Appendix J – Consultation Comments and Responses for PCC #1 and PCC #2

Public Consultation Centre #1 Summary

University Avenue between Albert Street and Weber Street, Class Environmental Assessment, Schedule 'C' and Preliminary Design

Prepared for Region of Waterloo
by IBI Group
December 8, 2020

Alternative 3a: Separated bike lane (off roadway) with concrete curb and enhanced sidewalk (2.1m wide where possible)

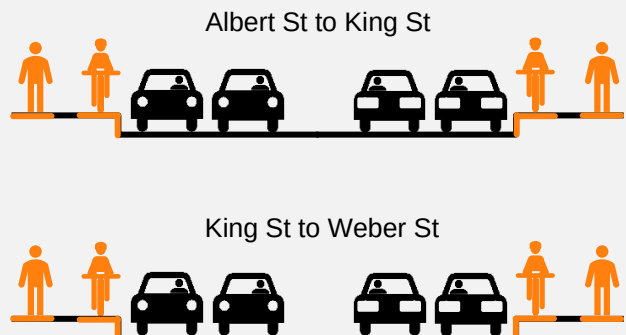
Comment (Grouped by Submission)	Response
(King to Hagey) in the region's pilot project. Has the data collected to date (counts and surveys of users) suggested this form of separation is preferred over the other three approaches in the pilot? 2. Alternative 3a's approach to separating cycling infrastructure is proposed to be similar to Columbia St (Fischer-Hallman to Erbsville), which uses a roll-curb/gutter. The voice-over in the presentation describes this as a curb as a physical barrier. If this is a raised curb that is higher than the level of both the roadway and the cycle track, it would act as a physical barrier. If it isn't, that would be similar to Columbia (FH-E) and University (Keats Way to Erb). Which description is most accurate about the intent? 3. This is a stretch of road where vehicle drivers are likely to want to stop (drop-off, delivery, parking) and would see a raised but not physically blocked area as a good place to do so. This behavior resulted in a retrofit on King St. in Uptown with flexible bollards being installed to clarify the intent of the space. While not a problem on University (Keats Way to Erb) and Columbia (F-H to Erbsville) due to the backlogged, suburban context, it would be a problem in this corridor. 4. How would you describe the turning radii in the proposed design(s) relative to the existing turning radii? Are they tighter (and by how much) or the same size? Are they measured to the travel lane or to the curb/outside edge of the cycling lane? 5. How does the design facilitate cyclists making left turns safely? I do not see bike boxes or spaces for two-stage left turns in the design (both of which are features of the Region's current pilot project, and, as	2. The physical barrier would consist of a full height barrier curb. The Project Team is currently evaluating specific curb alternatives. 3. Comment noted. The Project Team is currently evaluating all alternatives. The preferred alternative will be presented at PCC #2. 4. The turning radii will be determined during detail design. 5. The intersections and crossing with be further evaluated during detail design. 6. University Avenue Improvement project is generally limited to just past the curb returns. There is also currently planned works underway in the design stages for King Street. These designs will be coordinated and integrated with this project for connectivity and transitions. 7. Comment noted. 8. Scrambles have a massive impact on operations and do not necessarily result in safety improvements. They usually need to be supplemented with full-out left and right turn prohibitions to enhance safety. A few years ago, this intersection underwent pedestrian safety improvements which included offset crosswalks, enhanced lighting and pedestrian countdown signals which have actually enhanced safety quite significantly compared to past operations. Other further safety enhancements that we are assessing, given the constraints at this intersection, could include items such as left-turn phasing and leading pedestrian intervals to enhance pedestrian comfort and safety. Turn

Alternative 3a: Separated Bike Lane with a Physical Barrier

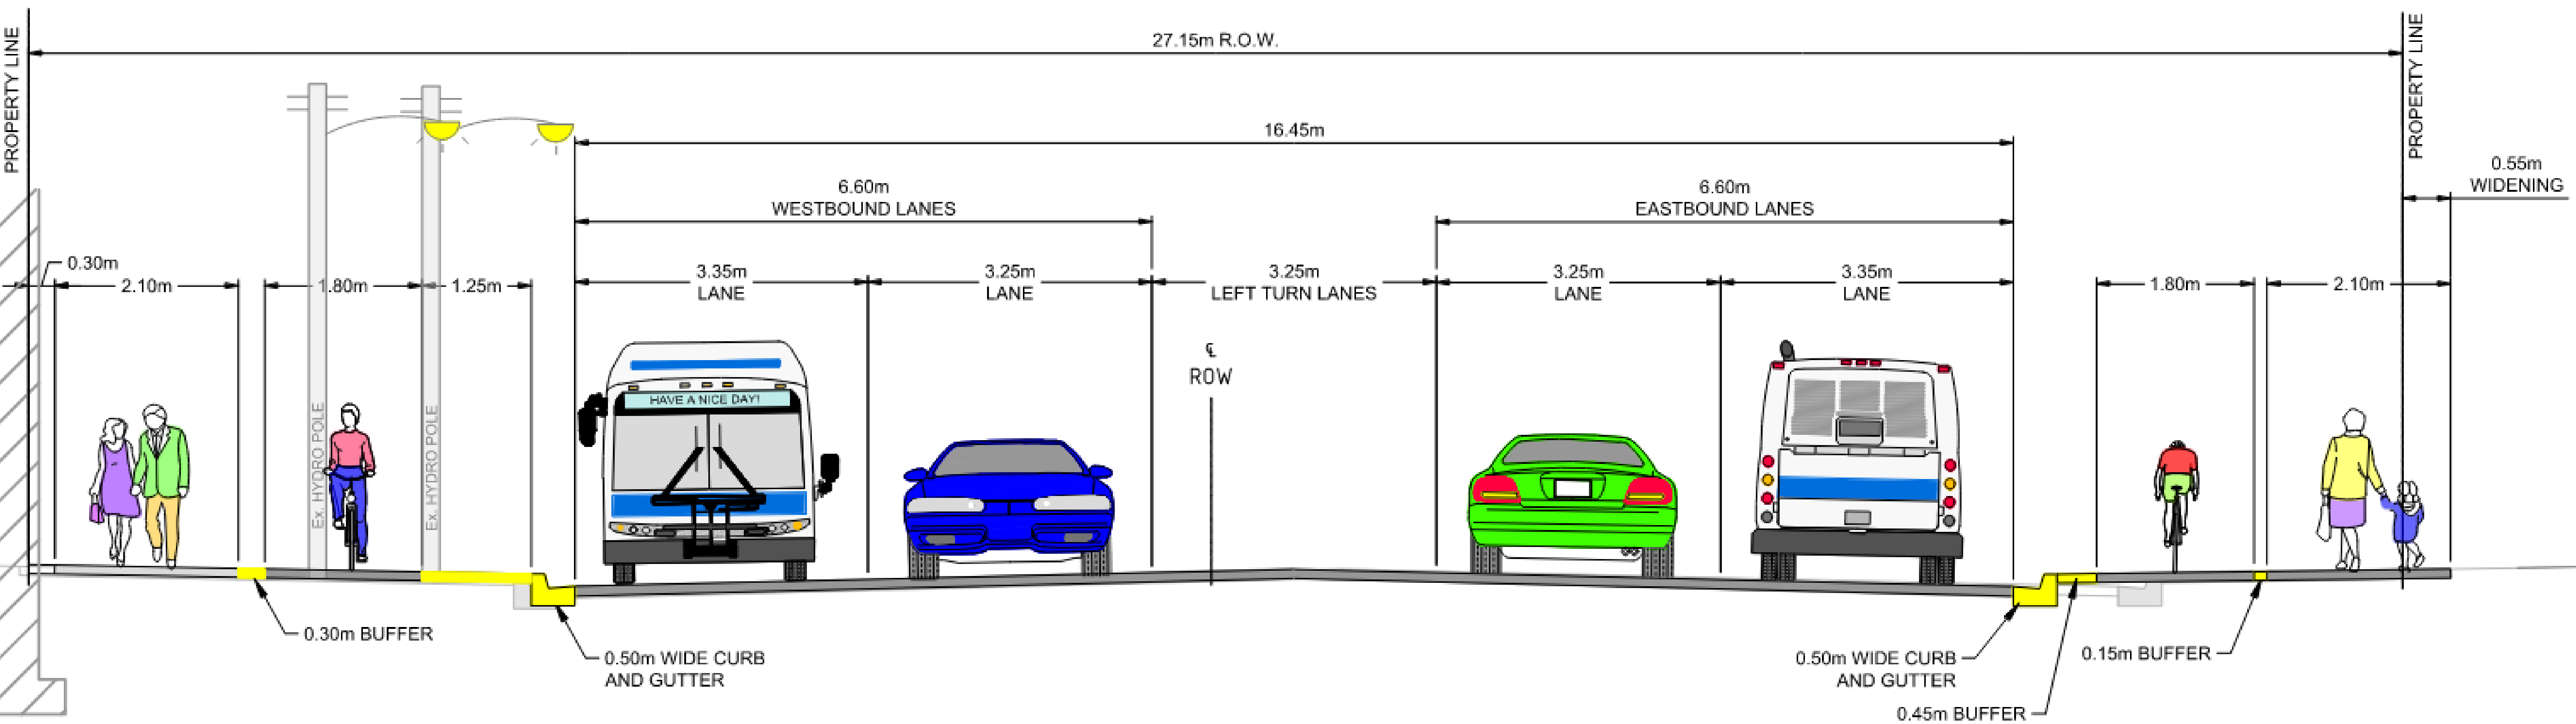
No.	Comment (Grouped by Submission)	Response
1.	<i>Q. What do you like about the Recommended Design Alternative for University Avenue Improvement Project</i> Separated bike line with a physical barrier - safety for pedestrians and cyclists	The Project Team acknowledges these comments, and they will be documented in the final study reporting (i.e. Environmental Study Report) for this Schedule C Class EA.

No.	Comment (Grouped by Submission)	Response
7.	<i>Q. What do you like about the Recommended Design Alternative for University Avenue Improvement Project</i> I like the improved pedestrian space and protected cycle lanes. I trust that the curb between cycle lanes and vehicles is a full vertical curb, NOT a roll curb. <i>Q. What challenges or considerations do you see with the Recommended Design Alternative?</i> I think a small grade separation between cycling and pedestrian space will be needed to minimize conflict. King St Uptown has shown that just different colours are not sufficient. Please also ensure that all intersections have crossrides and leading intervals are provided for both pedestrians and bicycles. Consider best practices for protecting the intersection as well. See NACTO	The Project Team acknowledges these comments, and they will be documented in the final study reporting (i.e. Environmental Study Report) for this Schedule C Class EA. The Project Team will evaluate the type of curb used to separate cyclists from the roadway during detailed design phase of the project. The intersections and crossings will be evaluated individually and as a whole during the detailed design phase of the project.

No.	Comment (Grouped by Submission)	Response
14.	<i>Q. What do you like about the Recommended Design Alternative for University Avenue Improvement Project</i> I really like the inclusion of bicycle lanes which are physically separated from vehicle traffic, this will make cycling along University Ave much safer and more attractive. The widening of sidewalks will make walking more comfortable, especially to the shops and bus stops along University Avenue. <i>Q. What challenges or considerations do you see with the Recommended Design Alternative?</i> "The use of channelized right turn lanes at Weber will increase the number of conflict points between vehicles and vulnerable road users (pedestrians and cyclists). Will the use of off-road bicycle lanes be accompanied by dedicated bicycle signals at signalized intersections? Or will pedestrians be expected to consider pedestrian signals? The detail drawings appear to not include dedicated bicycle crossing going north/south at the University and Weber intersection? Considering these are two major roadways, it would likely be beneficial to have bicycle facilities for all directions. The detail drawings appear to not include a dedicated bicycle crossing for the south approach of the University & Regina intersection? Are cyclists expected to use the pedestrian crosswalk at this location? With the addition of an extra vehicle lane, the midblock pedestrian crossing near 64 University Avenue West will have a pedestrian refuge island. Will the crossing remain as a one-stage crossing?"	The Project Team acknowledges these comments, and they will be documented in the final study reporting (i.e. Environmental Study Report) for this Schedule C Class EA. The Project Team will evaluate each intersection and crossing balancing all user needs during the detailed design phase of the project. The University Avenue Improvement project is generally limited to just past the curb returns. Any future works planned along Weber Street will be coordinated with and integrated with this project for connectivity and transitions. The intent is to maintain the mid-block pedestrian crossing near 64 University Avenue as a one-stage crossing
